**Do these OTU8K units below
have the B43 revision to be
able to control the new E9H-
X36LCAPC (UOS) switch?**

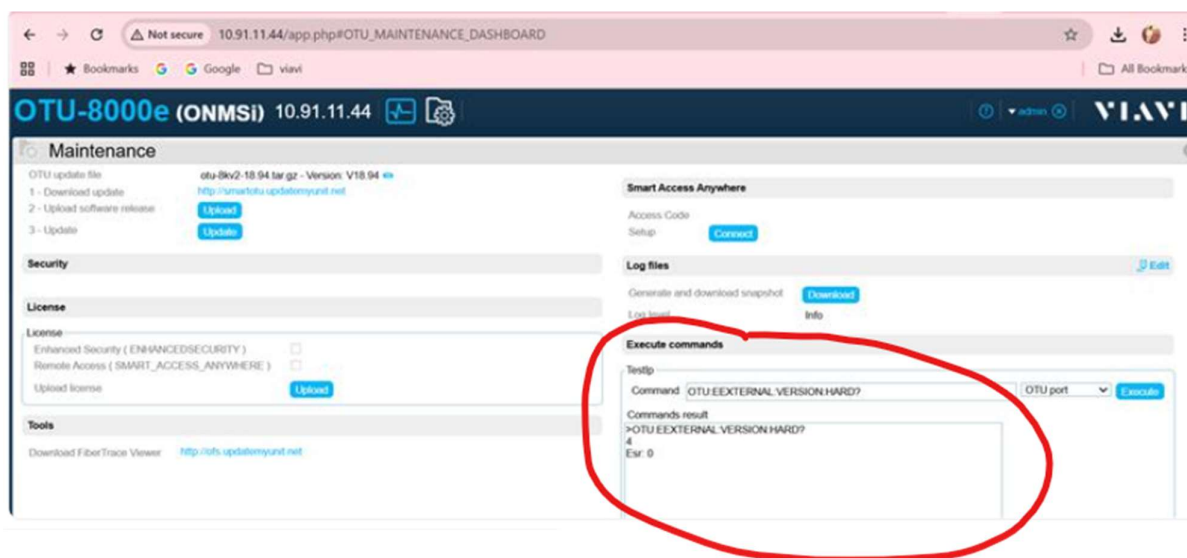
UOS possible only for otu8kv2 with hardware card B43 rev >= 6

Please, check SCPI:

OTU:EEXTERNAL:VERSION:HARD?

How to check using below procedure.

Answer:

All are v6 and above. See below.
